RE: REVISED DRAINAGE PLAN FOR AN ADDITION TO MARTINEZ SHOP
(L-14/D28) RECEIVED FEBRUARY 17, 1989 WITH AN ENGINEER'S
STAMP DATED FEBRUARY 17, 1989

RE: REVISED DRAINAGE PLAN FOR AN ADDITION TO MARTINEZ SHOP
(L-14/D28) RECEIVED JANUARY 24, 1989 WITH AN ENGINEER'S
STAMP DATED JANUARY 26, 1989

RE: DRAINAGE PLAN FOR AN ADDITION TO MARTINEZ SHOP
(L-14/D28) RECEIVED NOVEMBER 28, 1988
ENGINEER'S STAMP DATED NOVEMBER 27, 1988

SUBJECT: PRIVATE DRAINAGE FACILITIES WITHIN PUBLIC RIGHTS-OF-WAY/EASEMENT
MARTINEZ WAREHOUSE COMPLEX (L-14/D28)

JOB Martinez Addition
SUBJECT Off-Site Conveyance
JOB NO. _____ SHEET 1 OF 2
BY MG DATE 12/7/88
CHECKED _____ DATE _____

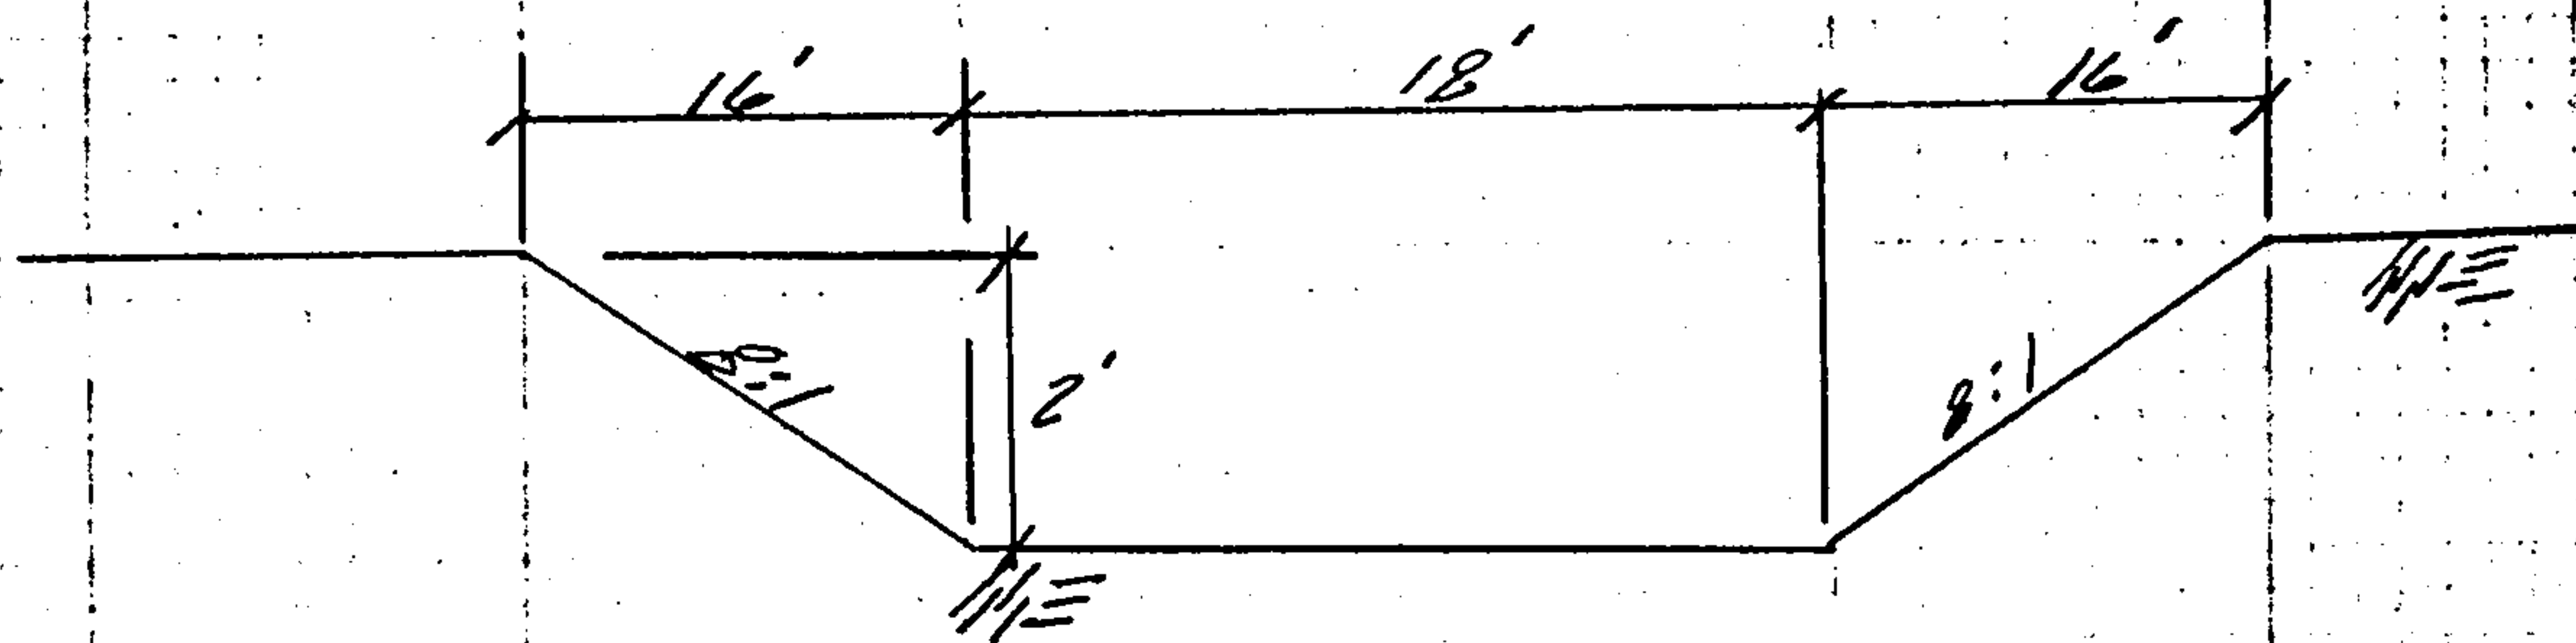
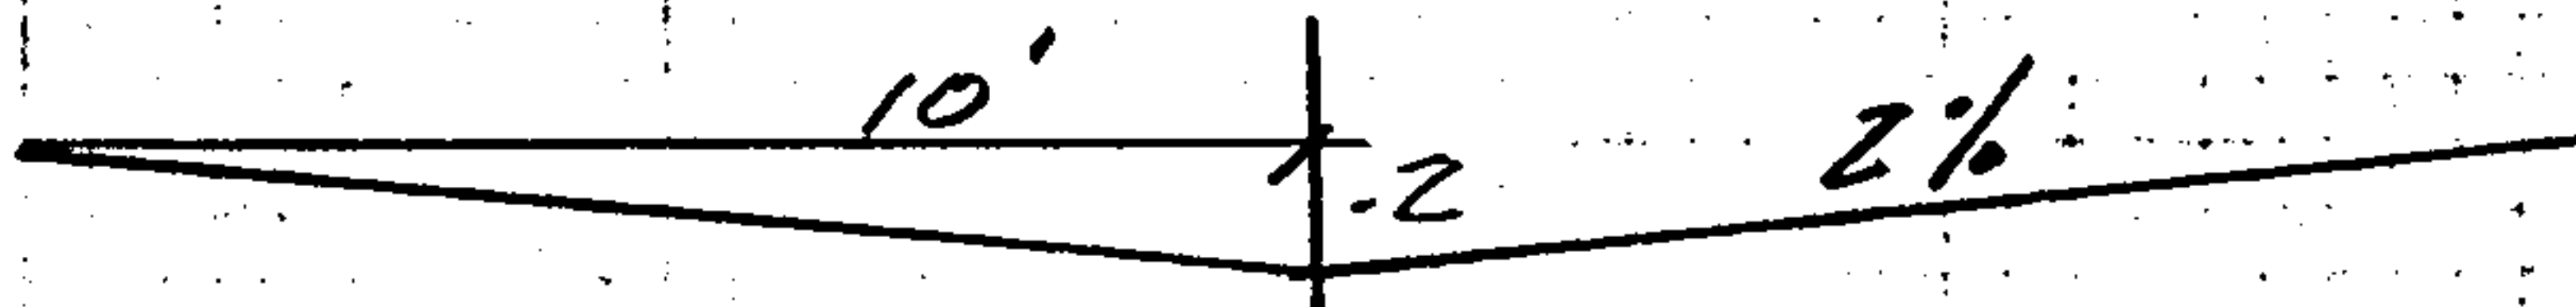
The Torreon Street R/W which receives a $Q_{100} = \overset{3.6}{\cancel{13}}$ cfs from the Martinez site is composed of 2 Typical Sections. Immediately W. of Martinez, the typical section is an improved earthen swale. This swale runs approx. 200 L.F. to Edith. At Edith, the typical section becomes a concrete swale which runs on down to the W. Flow capacity of the earthen swale is as follows:

$$S = 0.75\% \quad n = 0.03 \quad A = 68 \text{ ft}^2 \quad W.P. = 50.25'$$

$$V = \frac{1.486}{0.03} \left(\frac{68}{50.25} \right)^{2/3} (.0075)^{1/2} = 5.25 \text{ fps}$$

$$Q = 68(5.25) = 357 \text{ cfs} > \overset{3.6}{\cancel{13}} \checkmark$$

$$Q = 4.27 \text{ cfs} > \overset{3.6}{\cancel{3}} -$$

JOB Martinez Addition
SUBJECT On-site Conveyance
JOB NO. 111 SHEET 1 OF 2
BY MD DATE 12/17/18
CHECKED MD DATE 12/17/18
HYDROLOGY SECTION

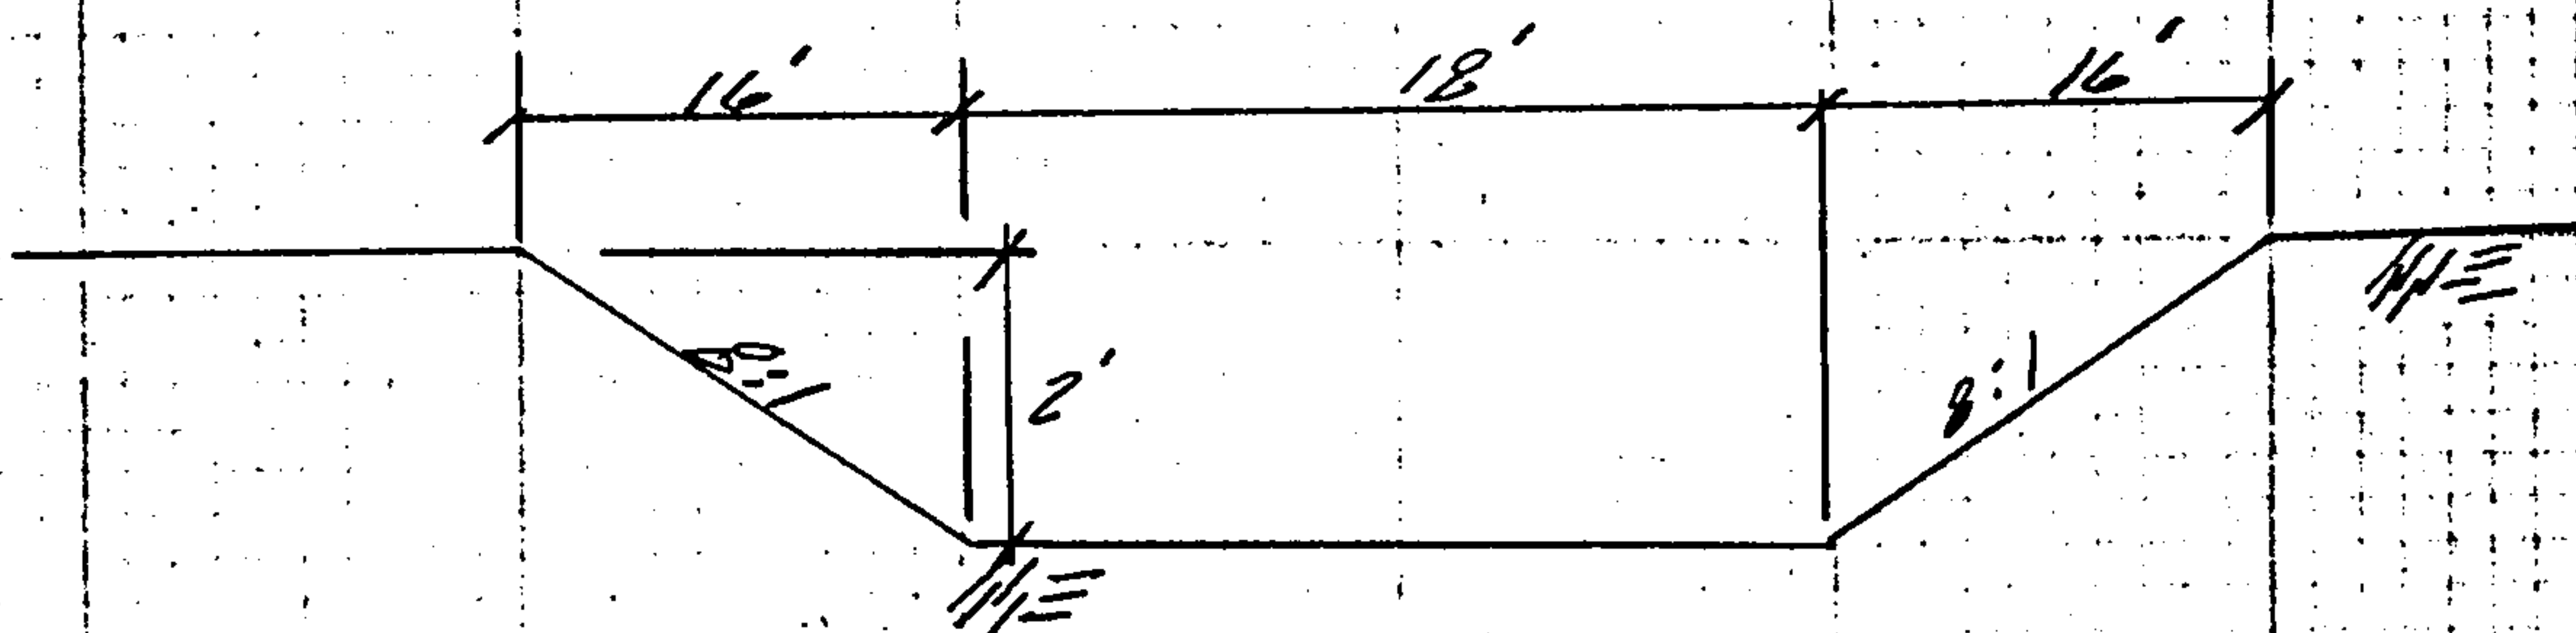
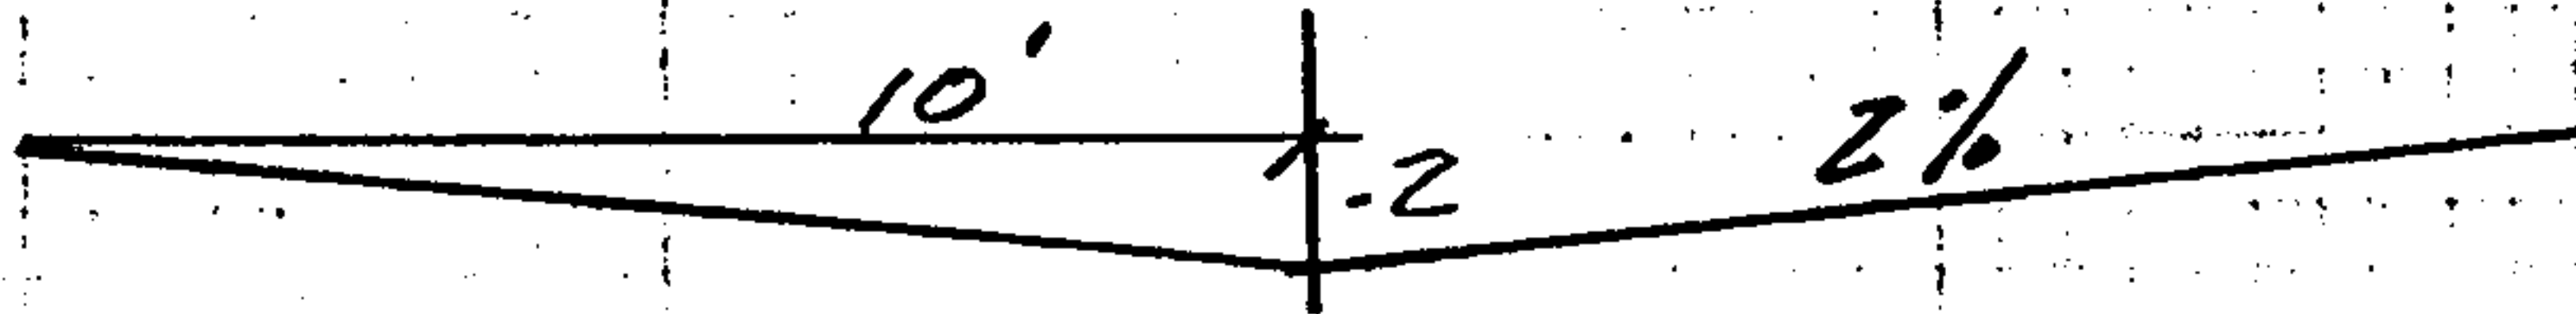
1. Downstream evaluation of Torreon.
 - a. Is the street paved with curb and gutter?
 - b. If the street is not improved, will the 1.3 cfs meander onto adjacent property downstream of the site?
2. If the area around the proposed addition is not paved, how will sediment deposits into the street be controlled?
3. Your calculations indicate that you are probably building over existing asphalt. Is this true? If so, then it is historical conditions and the above two comments are not applicable.
4. Will you require any type of compaction specs for the berm.

The Torreon Street R/W which receives a $Q_{100} = 1.3$ cfs from the Martinez site is composed of 2 Typical sections. Immediately W. of Martinez, the typical section is an improved earthen swale. This swale runs approx. 200 L.F. to Edith. At Edith, the typical section becomes a concrete swale which runs on down to the W. Flow capacity of the earthen swale is as follows:

$$S = 0.75\% \quad n = 0.03 \quad A = 68 \text{ ft}^2 \quad W.P. = 50.25'$$

$$V = \frac{1.486}{0.03} \left(\frac{68}{50.25} \right)^{2/3} (.0075)^{1/2} = 5.25 \text{ fps}$$

$$Q = 68(5.25) = 357 \text{ cfs} >> 1.3 \quad \checkmark$$

$$Q = 4.27 \text{ cfs} > 1.3 \text{ -}$$
